**CHANGE TO THE OPERABLE UNIT 3 BUILDING 4A  
IMPLEMENTATION PLAN FOR ABOVE GRADE DECONTAMINATION AND  
DISMANTLEMENT**

DOE-1245-95  
DOE-FN        EPAS  
6  
LETTER

**CHANGE TO THE OPERABLE UNIT 3 BUILDING 4A IMPLEMENTATION PLAN FOR ABOVE-GRADE  
 DECONTAMINATION AND DISMANTLEMENT**

FIGURE 2-1 Proposed Locations For Plant 4 Complex Air Monitors

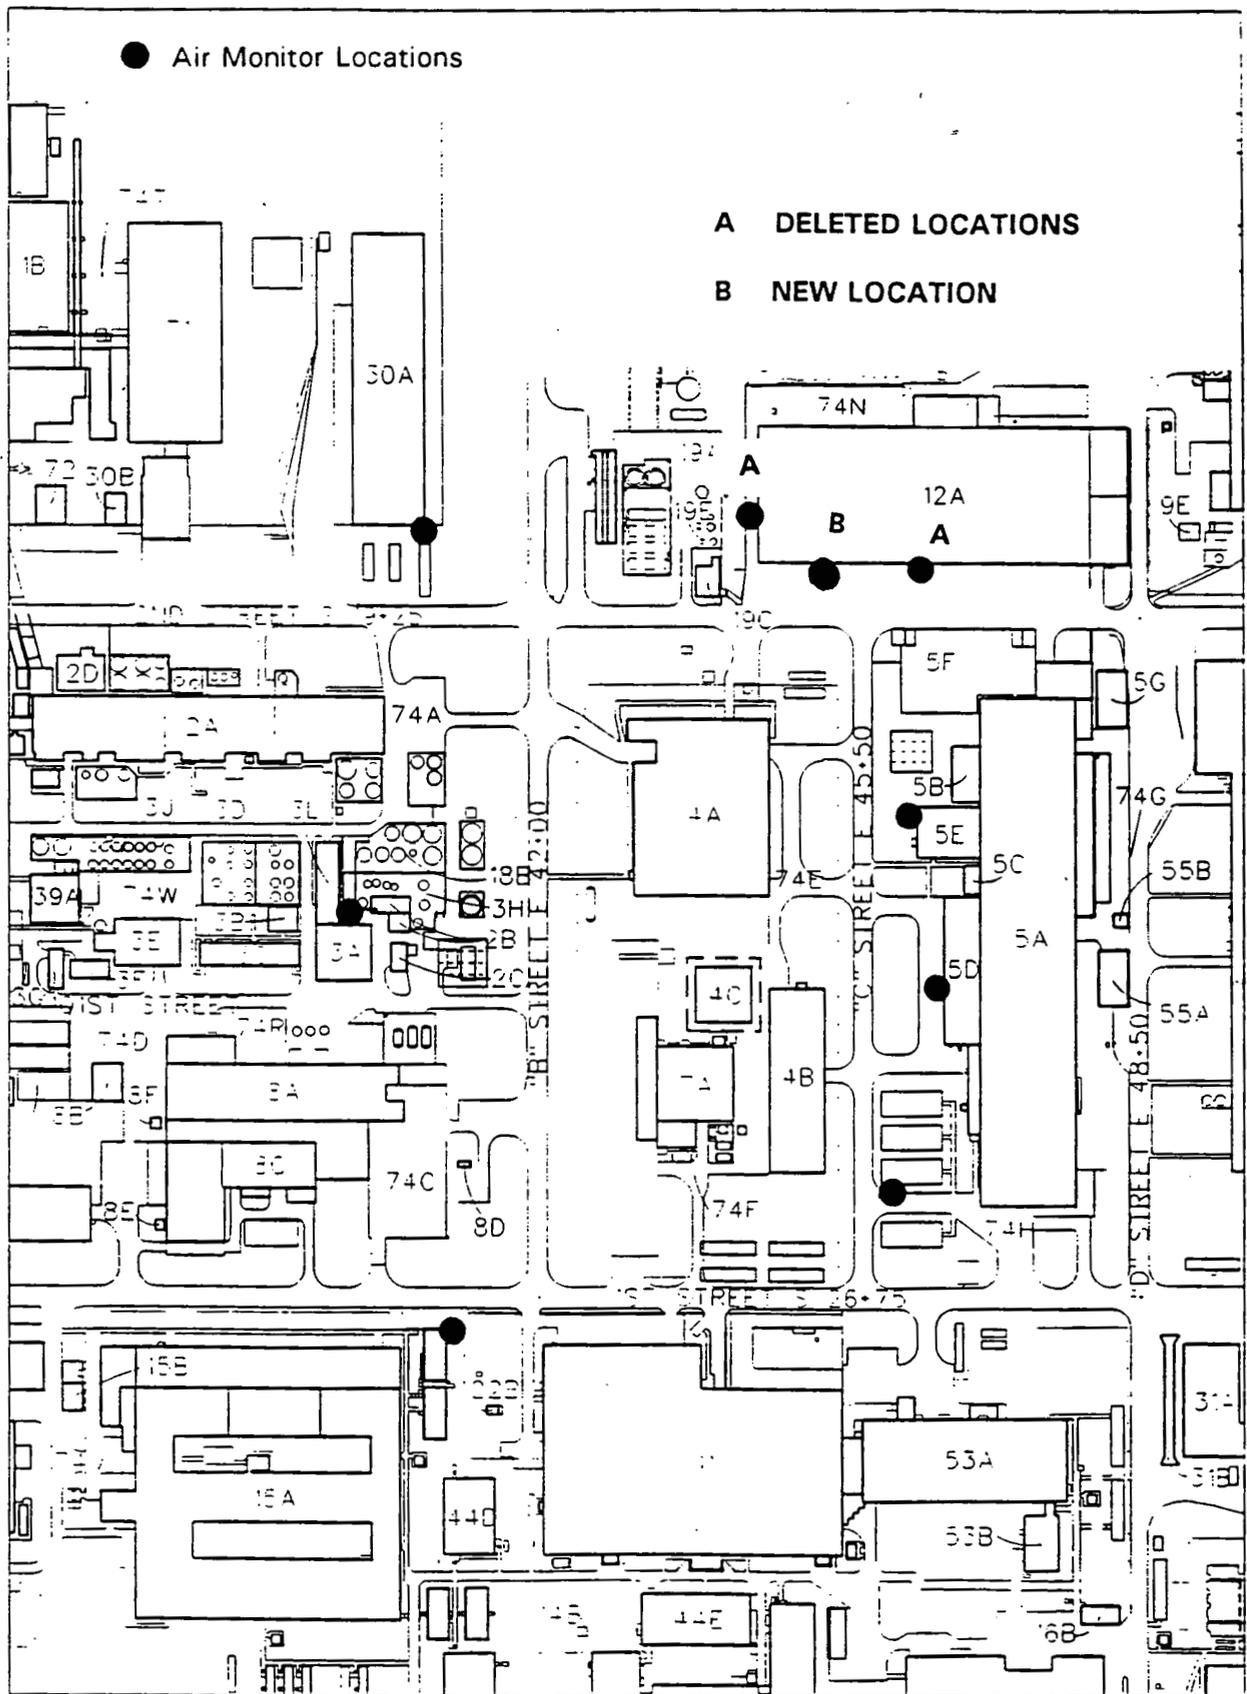
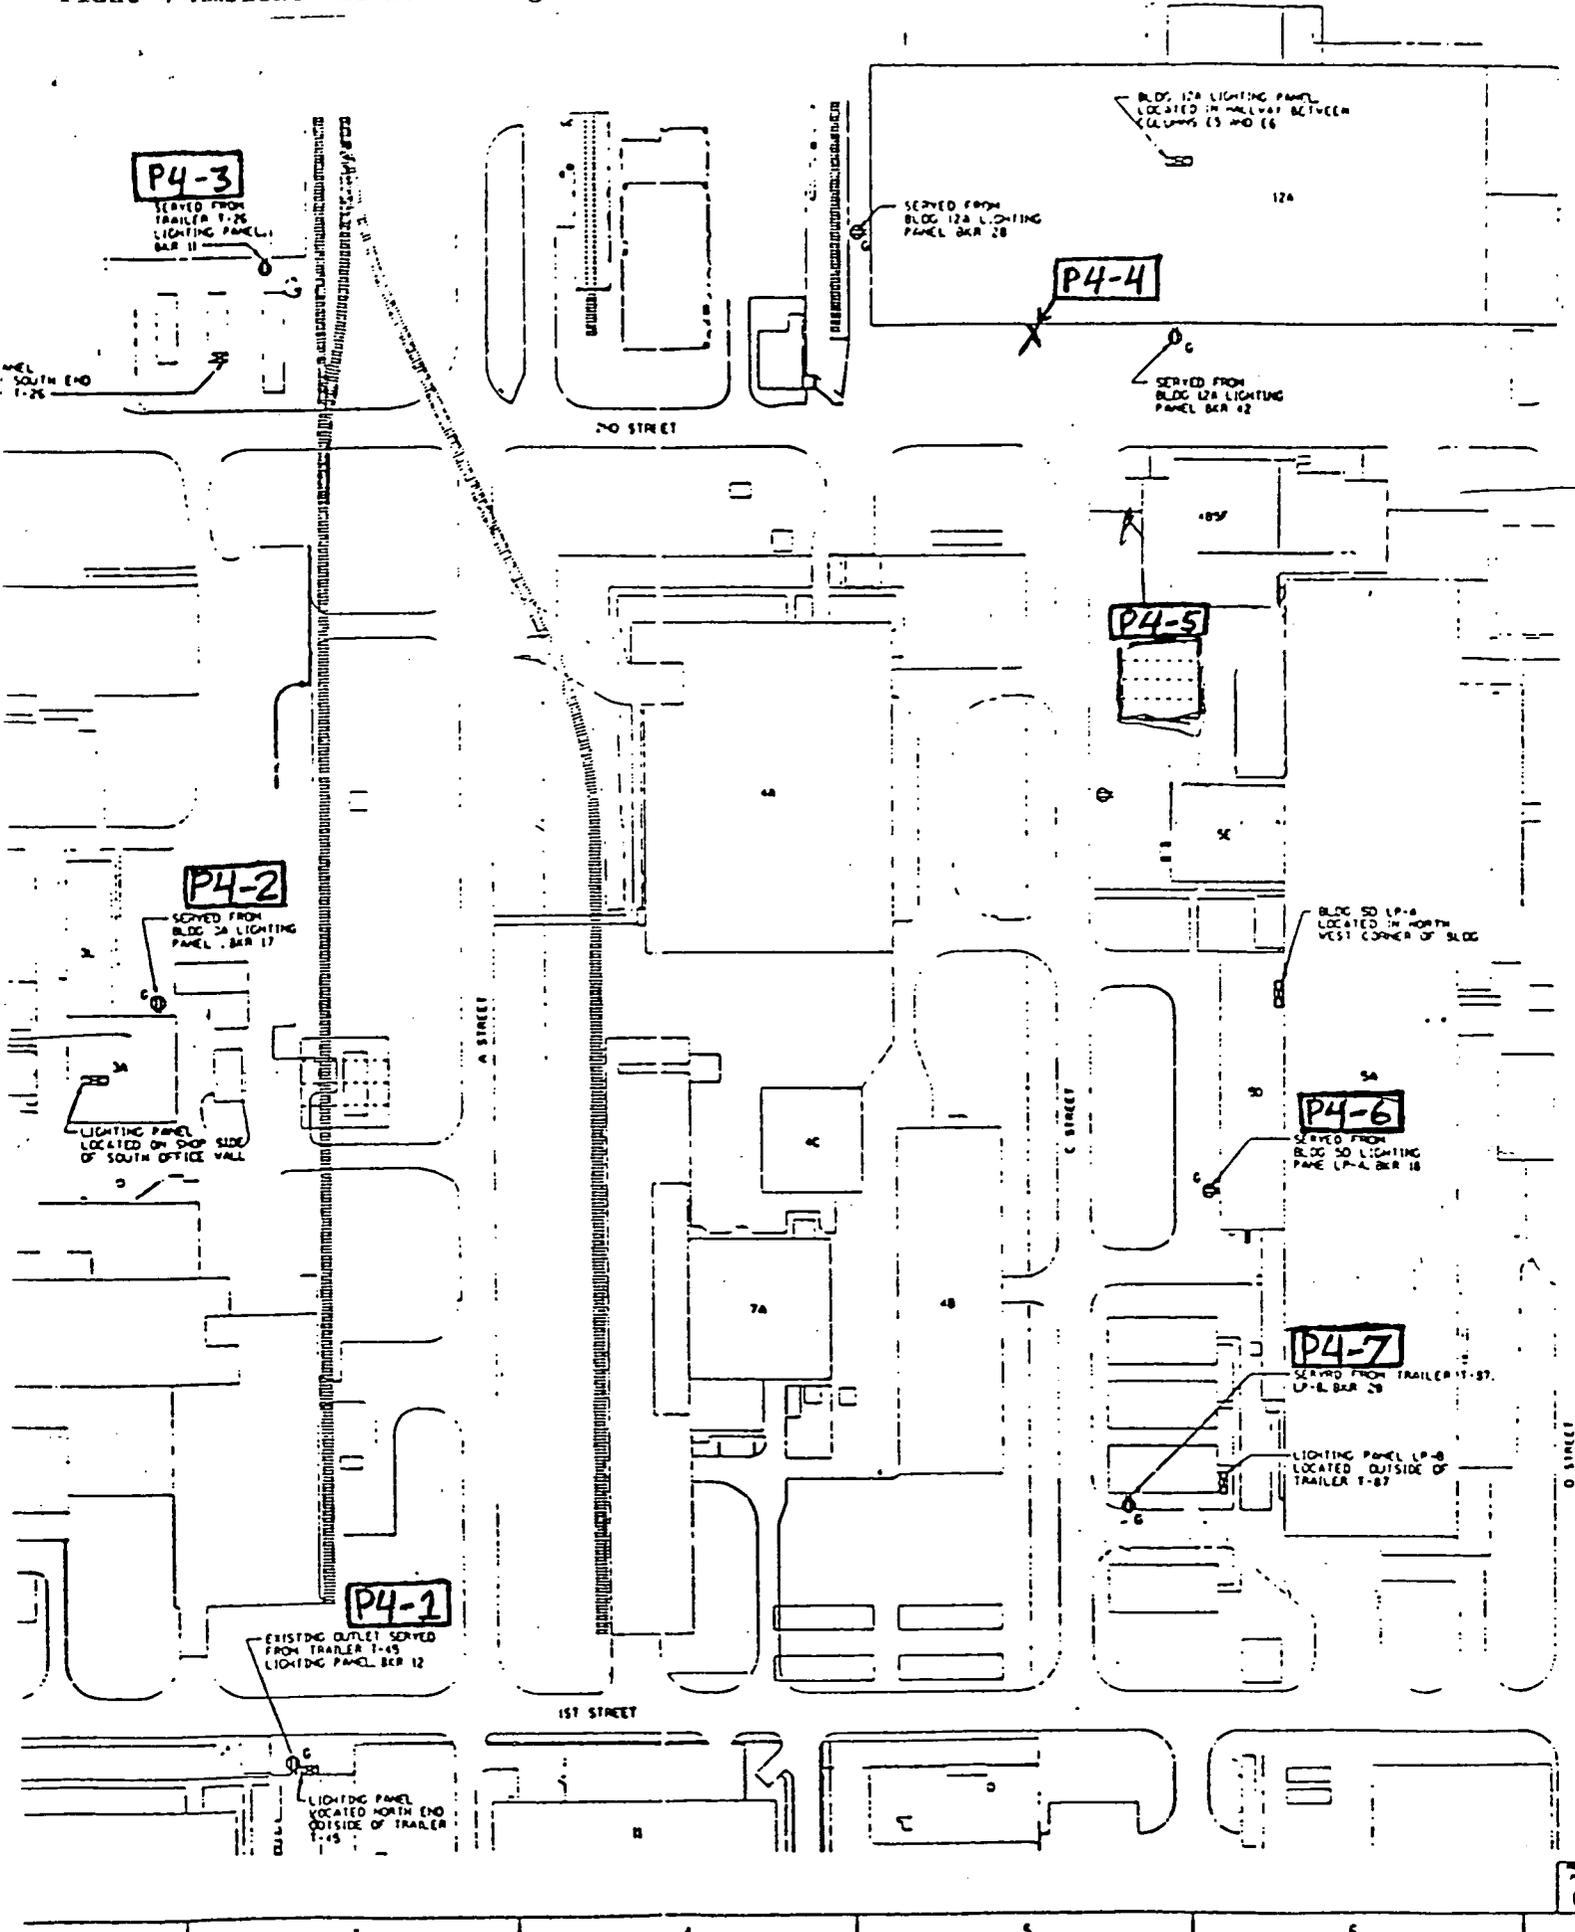
The intent of this letter is to request your concurrence to a change to the Operable Unit 3 (OU3) Building 4A Implementation Plan for Above-Grade Decontamination and Dismantlement for supplemental radiological air monitoring. Air quality monitoring that is being performed during the Building 4A decontamination and dismantlement project includes two programs: 1) The current site-wide monitoring program plan, and 2) the Supplemental Radiological Air Monitoring Program, specifically designed for the decontamination and dismantlement of Building 4A as discussed in Section 3.7.3 of the OU3 Remedial Design/Remedial Action (RD/RA) Work Plan. The OU3 Building 4A Implementation Plan for Above-Grade Decontamination and Dismantlement (Final, March 1995) further defines the Supplemental Radiological Air Monitoring Program. Section 2.3 of the OU3 Building Implementation Plan states:

"Based on the factors listed in Section 3.7.3 of the OU3 RD/RA Work Plan, air emissions modeling was performed to determine the potential emissions from remediation. The results of that modeling effort indicate levels of radiological emission will not exceed the 0.1 mrem/year threshold at the project boundary that would require continuous emissions monitoring. However, as a conservative measure to ensure protection of human health and the environment, eight continuous air monitors will be employed to supplement current site-wide air monitoring on a continual basis surrounding the project boundaries during the interim remedial action. These monitoring locations for Building 4A are identified in Figure 2-1."

Prior to placing the monitors in the field, the location and the number of continuous air monitors required to meet the intent of the OU3 RD/RA Work Plan and Building 4A Implementation Plan (IP) were further reviewed. The review was based on the following factors: Expected dispersion of airborne releases, representativeness of the monitoring locations; the potential hazard of the material to be released; and accessibility to the monitoring station. Based on this review, it was determined that seven continuous monitors were adequate to meet the requirements of the OU3 RD/RA Work Plan and Building 4A IP. The Building 4A enclosed Figure 2-1 indicates a monitor should be placed on both the west wall and the south wall of Building 12A. These locations have been combined and a single monitor has been employed along the south wall of Building 12A, west of the original location located along the south wall. The original locations are in close proximity to one another and it appears would add no additional value to the air monitoring program. The new location will provide data that is representative of the two previously proposed locations. The new location increases the accessibility to the air monitoring station for maintenance and calibration without sacrificing the ability to detect the anticipated dispersion of airborne releases. Combining these two monitoring locations will not decrease the ability of the monitoring program to meet the OU3 RD/RA Work Plan objectives. Also, enclosed are the summary analytical results for the seven monitoring locations for April, May, and June.

As stated in Section 4.6.5, Remedial Action Reports, of the OU3 RD/RA Work Plan, any modifications to the OU3 RD/RA Work Plan and/or IP is required to be documented in the Remedial Action Report. This change to the Supplemental Radiological Air Monitoring Program will be documented in the Building 4A Remedial Action Report.
